March 3, 2023

***Re: Response to Deficiency Letter and Request for Additional Information
Application for Liquid Waste Handling Facility Permit
Green Era Renewable Energy and Urban Farming Campus
650 West 83rd Street
Chicago, IL 60620***

ATTACHMENT 1
RESPONSE TO REQUESTS FOR ADDITIONAL INFORMATION

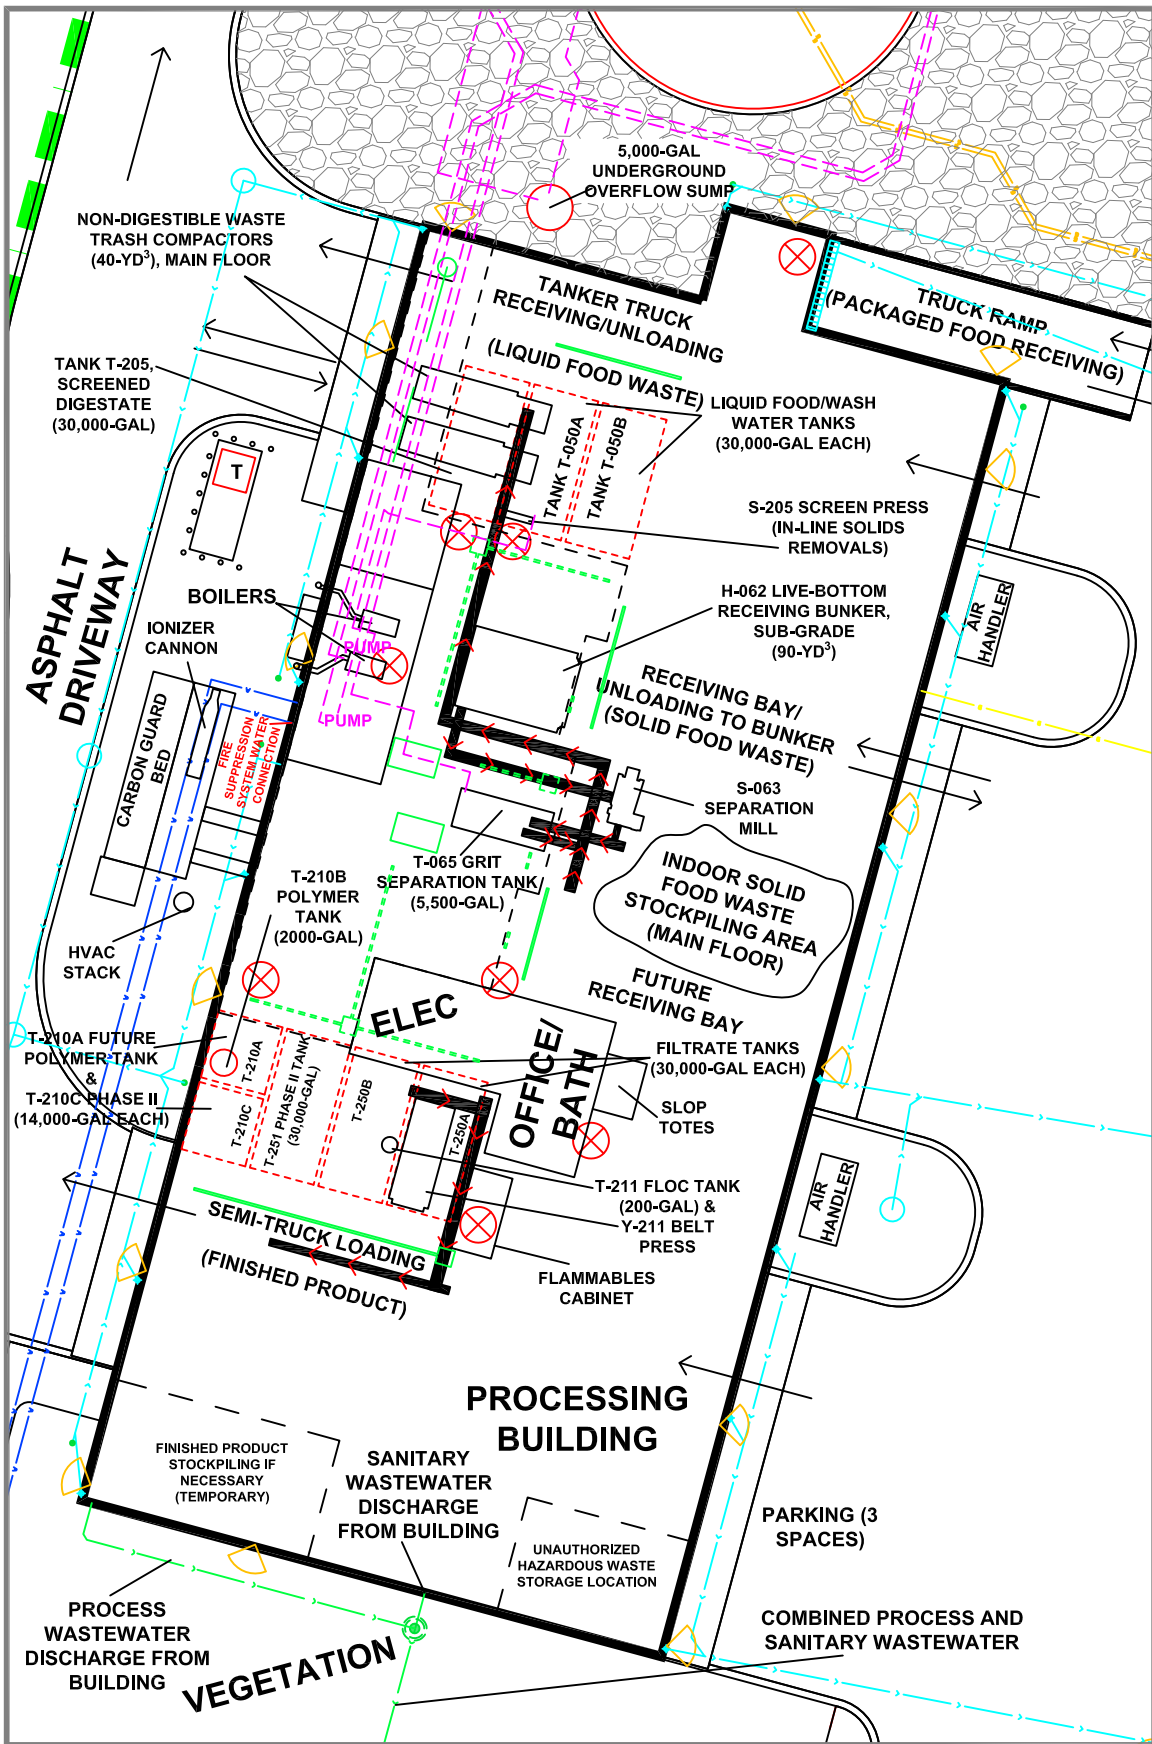
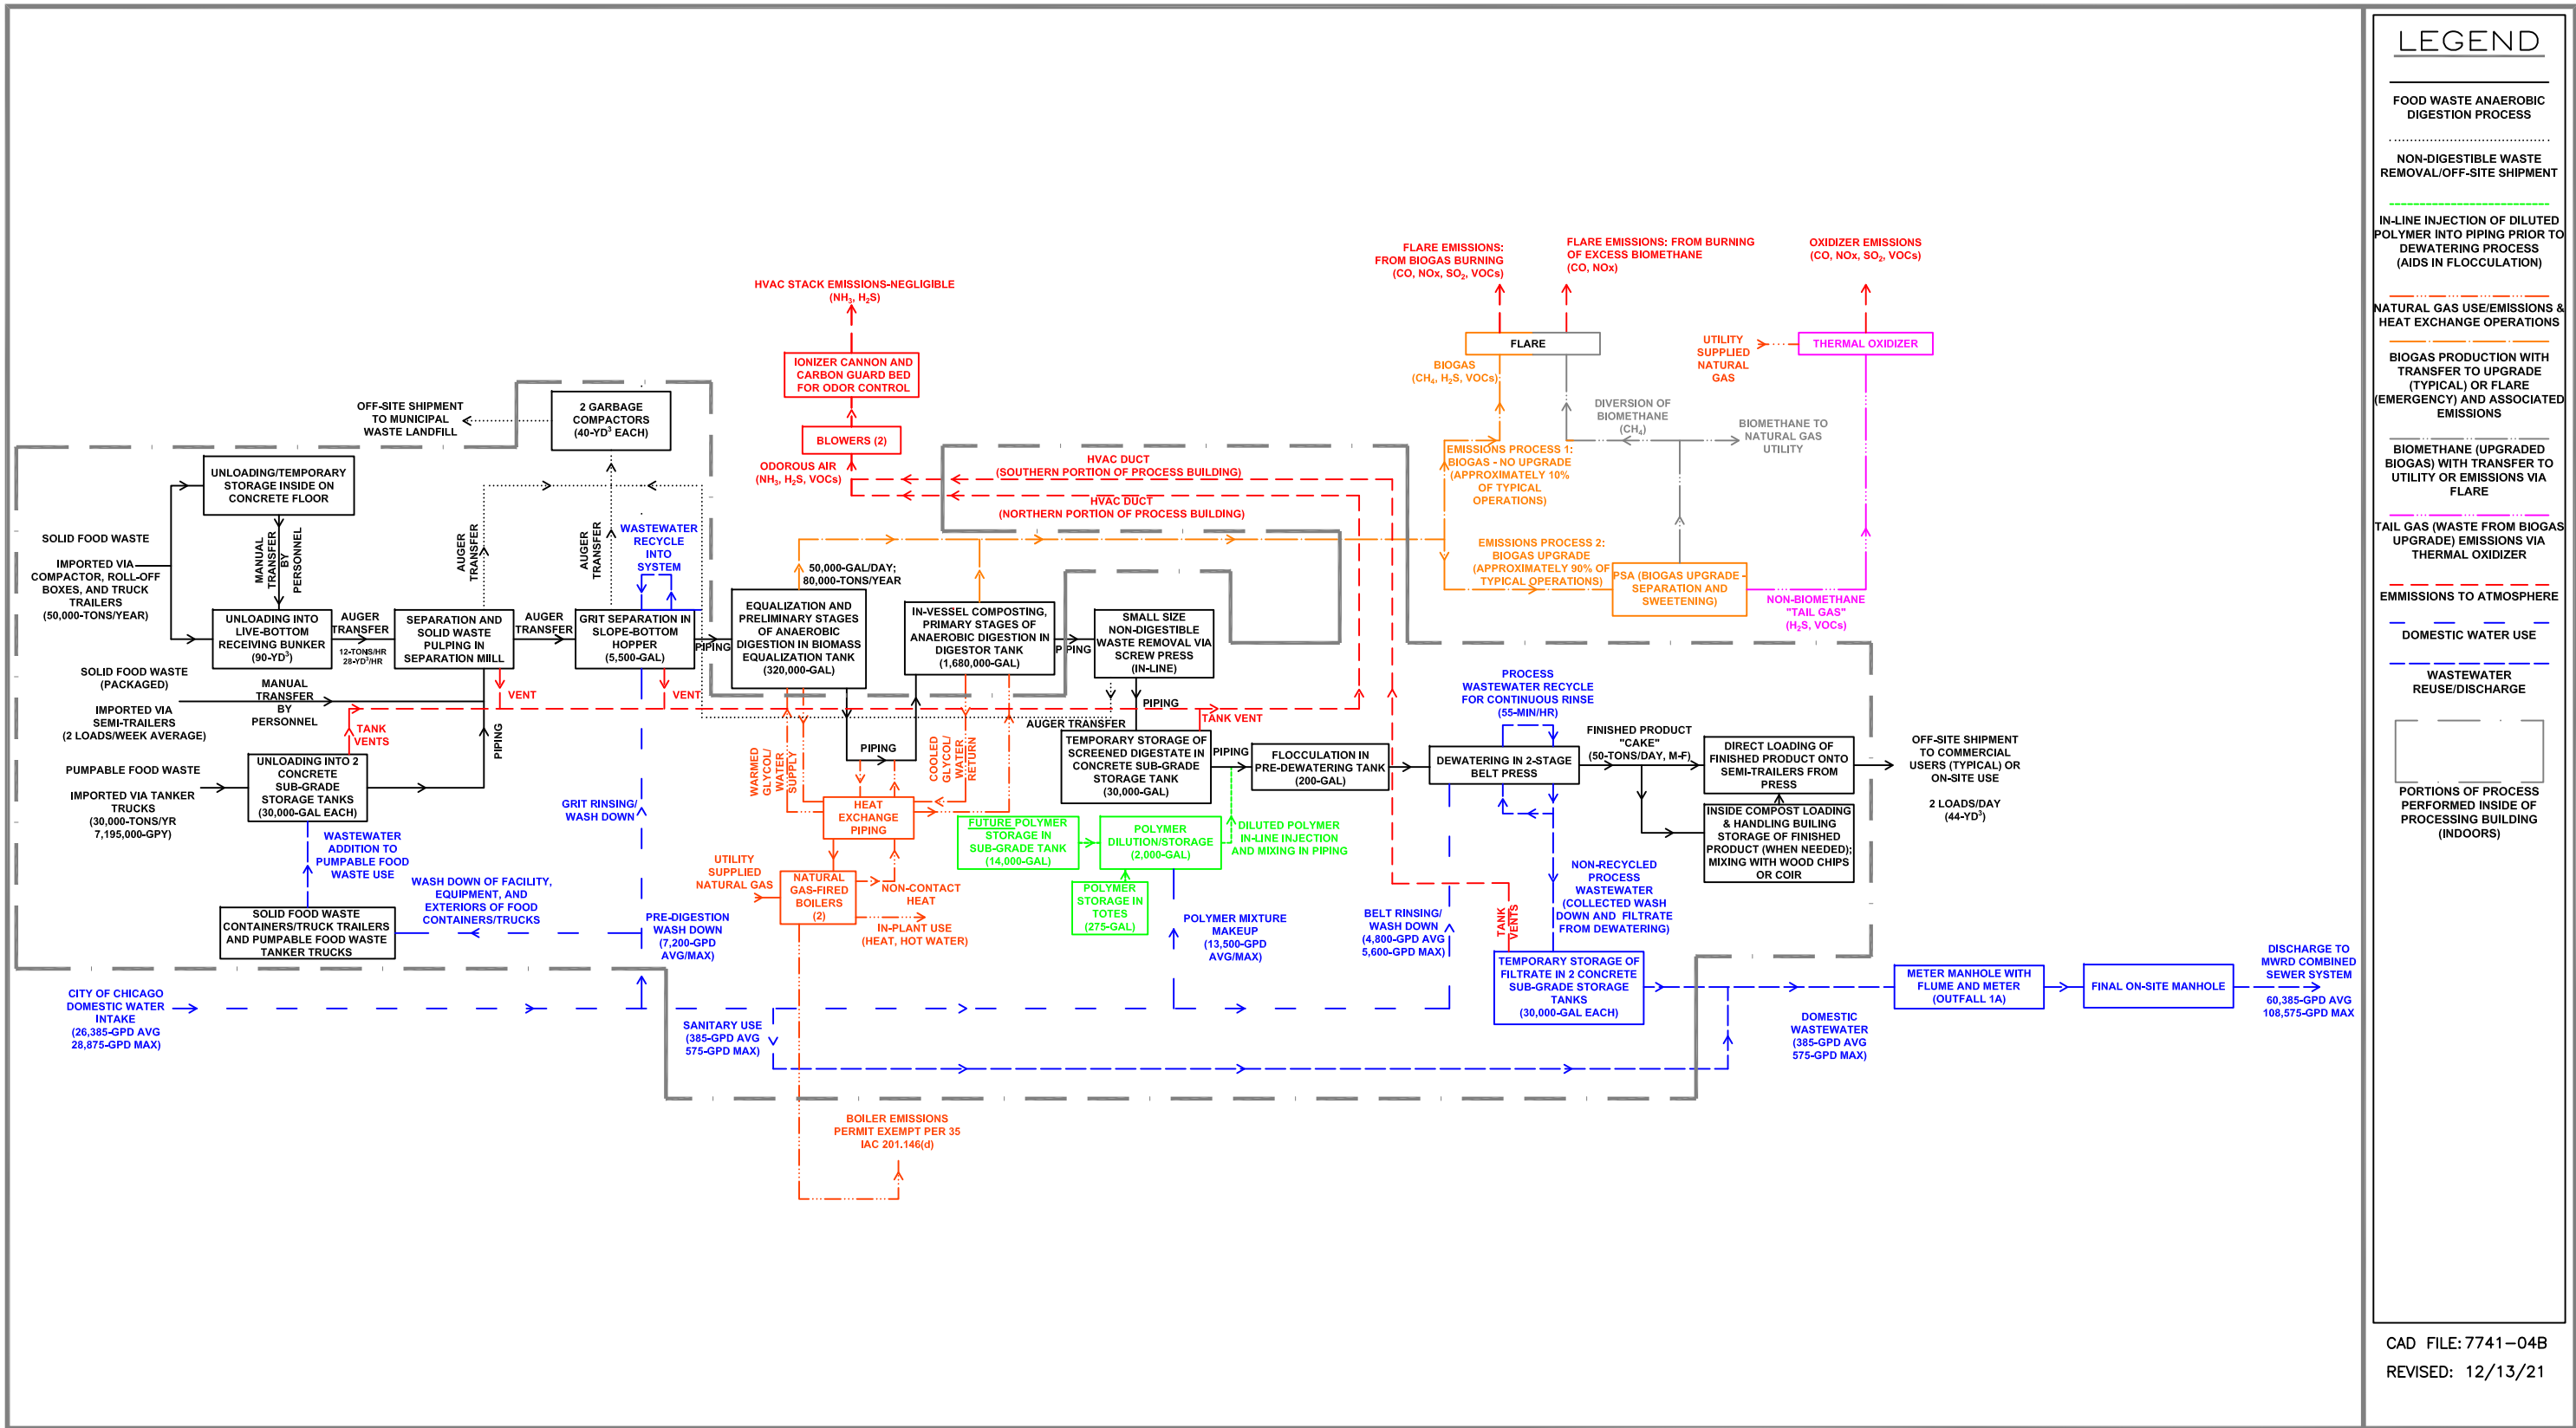
1. Pursuant to 8.4.4.9 of the Rules, provide the locations of all fire suppression equipment, including fire extinguishers, and all flammable material storage areas.

Response: Figure 3A (previously submitted) in Attachment 2 provides the traffic flow directions in/out of the facility. The process building detail provided as Figure 3B in Attachment 2 also shows the truck routing.

Response: Attachment 2 provides an update to Figure 3A (originally provided in the February 2022 permit application) that addresses the requirement. Additionally, a process building detail is provided as Figure 3B. Both figures show the locations of fire extinguishers around the building, the location of the fire water system piping entering the building, and the location of the flammable material storage cabinet. Attachment 3 provides a fire pump detail and a schematic of the fire sprinkler system layout.

FIGURE 5
POTENTIOMETRIC SURFACE MAP
(SEPTEMBER 30, 2022)

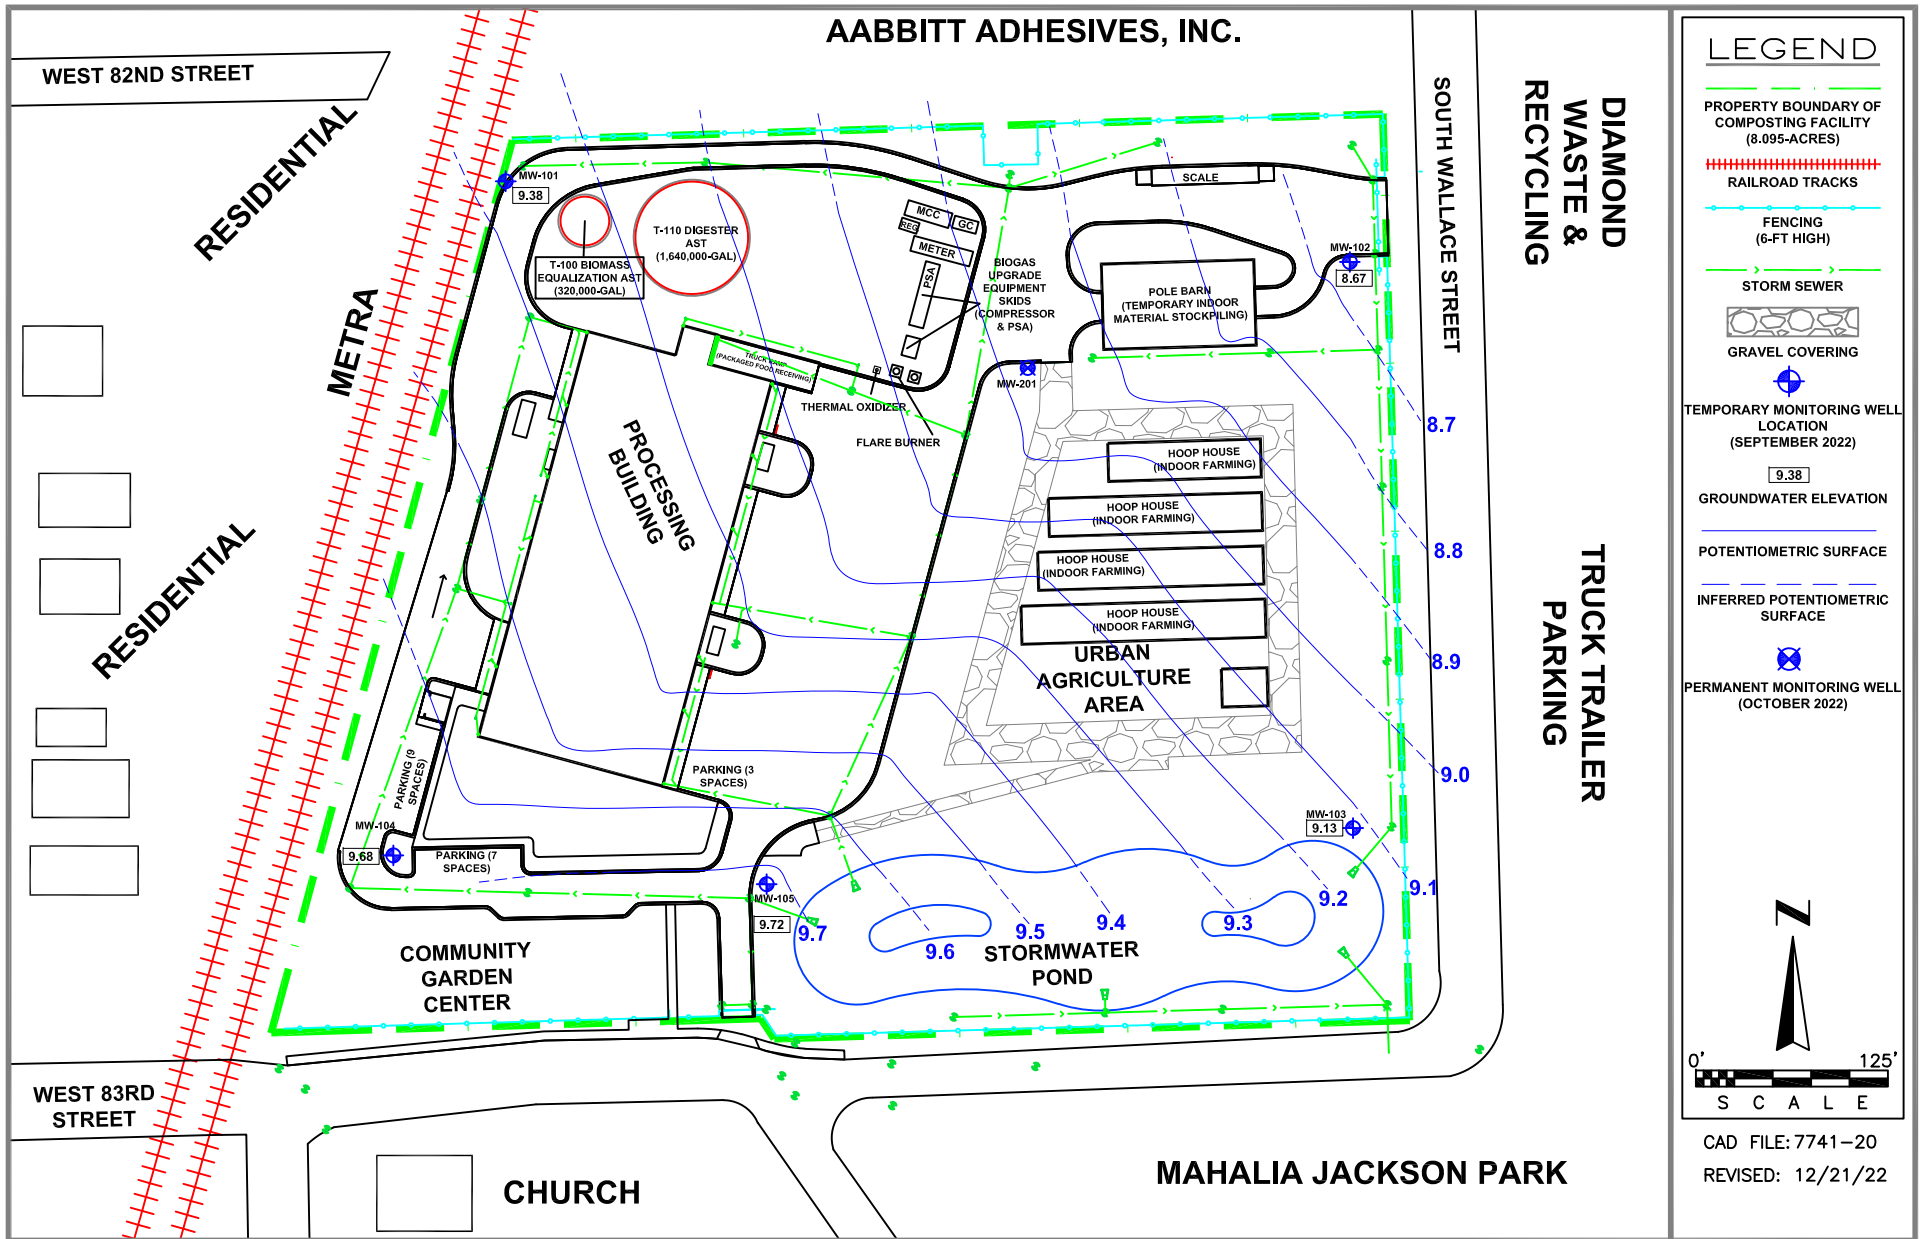
6. *Pursuant to 8.4.20 of the Rules, provide the locations of monitoring wells at the Facility designed to detect releases from the waste handling operations. Such information shall include, but not be limited to:*
 - a. *drawings indicating the location of all monitoring wells and piezometers;*
 - b. *the construction details of the above wells and piezometers;*
 - c. *a narrative explaining that the horizontal and vertical spacing of well screens are capable of detecting releases at the Facility; and*
 - d. *a description of monitoring well abandonment procedures which detail any backfilling or sealing to prevent the abandoned well from serving as a potential contaminant pathway.*

Per discussions with CDPH, in lieu of the requirement for potentiometric surface maps representing four (4) quarters of time, the current groundwater flow direction below the facility was to be determined from the five (5) temporary monitoring wells installed in September 2022, and that groundwater flow direction was used to determine the placement of the permanent monitoring wells that would be used as part of the required ongoing groundwater monitoring (per 8.5.10 of the Rules). The potentiometric surface map completed from the September 30, 2022, measurements is provided as Figure 5 (see Attachment 2).

The locations of the temporary monitoring wells are shown in Figure 5. After allowing time for the wells to recharge and equilibrate, Terracon returned on September 30th to survey and collect static water level measurements. The measurements were utilized to determine the current groundwater flow direction below the facility. As shown in Figure 5, a northeasterly groundwater flow direction was observed.

With the groundwater flow direction confirmed, a permanent 2-in diameter monitoring well (MW-201) was installed on October 6, 2022 (see Figure 5). (Temporary monitoring wells were removed and abandoned with bentonite.) The location of the well is downgradient of the Processing Building operations in the approximate center-north of the overall facility. The well is also cross-gradient/downgradient of the outdoor storage tank and equipment area.

As noted, a southeasterly groundwater flow direction under a hydraulic gradient of 0.001 was observed by Terracon during environmental Site Investigation activities (see potentiometric surface map in Attachment 9). The September 30, 2022, potentiometric surface map (see Figure 5 in Attachment 2) shows a northeasterly groundwater flow direction under a hydraulic gradient of 0.0014 ((9.6-8.7)/655).

**FIGURE 6A
STRATIGRAPHIC CROSS-SECTION
(A-A')**

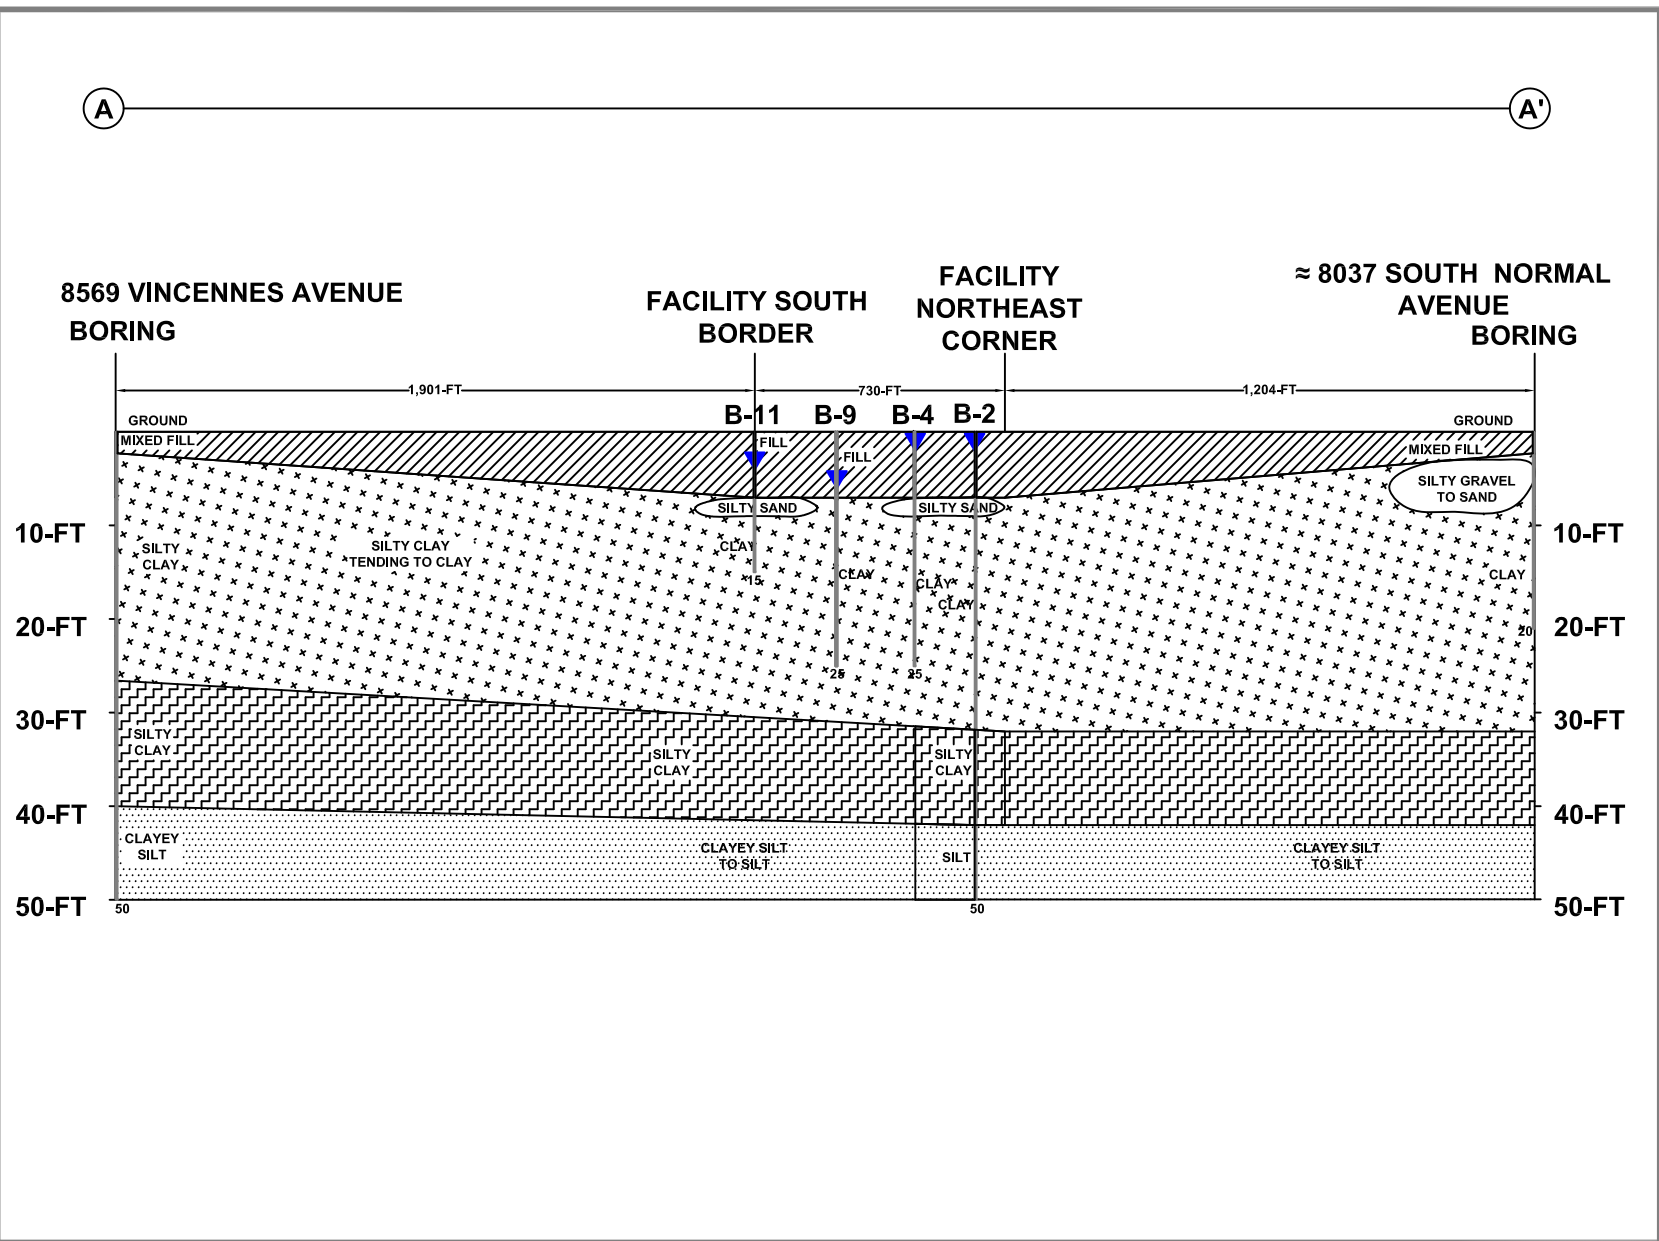
8.4.21.2. Logs of all soil borings taken at the facility. Sufficient site-specific hydrogeological information shall be obtained to verify that hydrogeological conditions will protect the public health, safety and welfare. All borings shall be continuously sampled in accordance with appropriate testing standards and shall be retained for City inspection until such time as a permit has been issued. The boring logs shall provide an accurate depiction of the site geology extending down to the bottom of the uppermost aquifer or 20 feet below the surface or bedrock, whichever is shallower.

Figures 6A and 6B in Attachment 2 provide the two (2) required stratigraphic cross-sections. Figure 6 provides the overview figure for the cross-sections.
